## Response to the comments of anonymous referee #2

The article presents the calibration and the evaluation of the ORCHIEE land-surface model over France. The article has several major limitations. Several important choices of the methodology applied by the authors are not well explained or justified. The model version with modified parameters sets provides less biased results than the standard version, but it is difficult to evaluate whether the results should be considered as satisfactory over the test domain due to the lack of external benchmark. Besides some explanations on model failure remain unverified hypotheses.

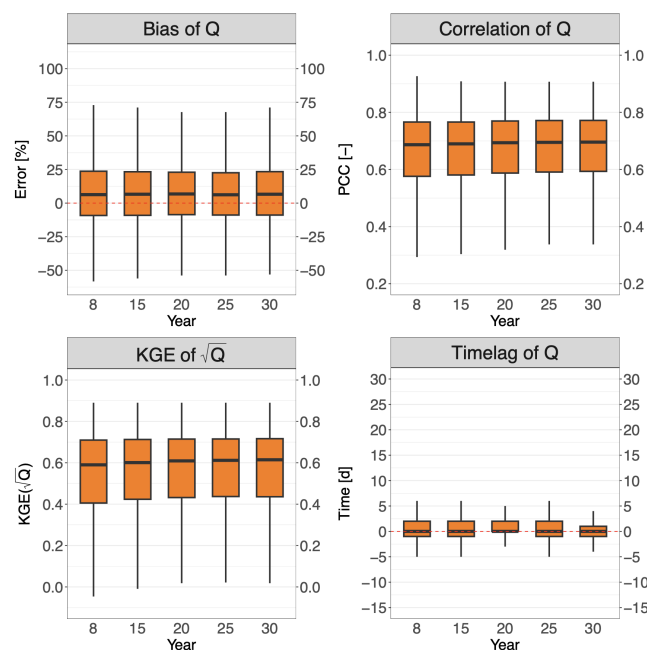
9. Section 2.3: It is unclear whether the observed time series were visually checked before use.

In large datasets, there are often many remaining observational errors, which may strongly influence model evaluation.

Response: The observed Q time series were not fully visually checked before use given the thousands of stations collected in the project.

Response: Thank you for point out this and we will add this aspect in L427 of Section 4: “Besides, Q records of the selected 1785 stations are not fully checked because identifying Q anomalies is extremely time-consuming and subjective. The remaining observational Q errors might influence model evaluation.”

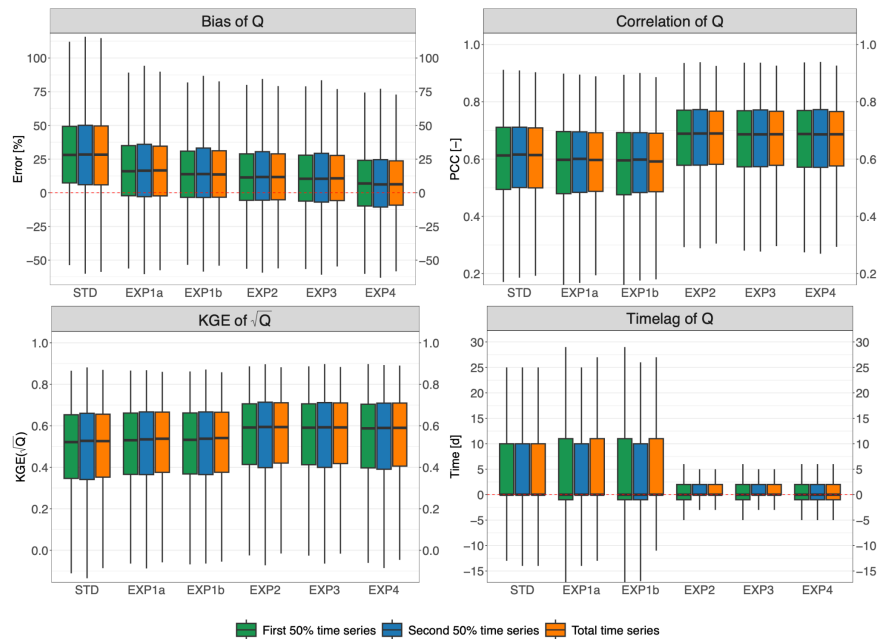
It is also unclear how the criteria calculated at each station were aggregated to get an overall performance at the level of the catchment set (e.g. the KGE criterion may generate highly negative values which may bias the calculation of the mean performance), which weight was given to ET and Q respectively during calibration (i.e. how the authors cope with the multi-objective aspect of calibration), and how the criteria were actually used in the calibration process.

Response: We do not calculate the mean values of the performance criteria but the medians and quartiles via boxplots to summarize their full distribution.

Since manual calibration is used in our study (no optimization), we don't need a function to combine all the performance criteria as one objective function. Instead, we consider all the information from performance criteria and we eventually choose the parameter set with experience and judgment even though there are some compromises to make.
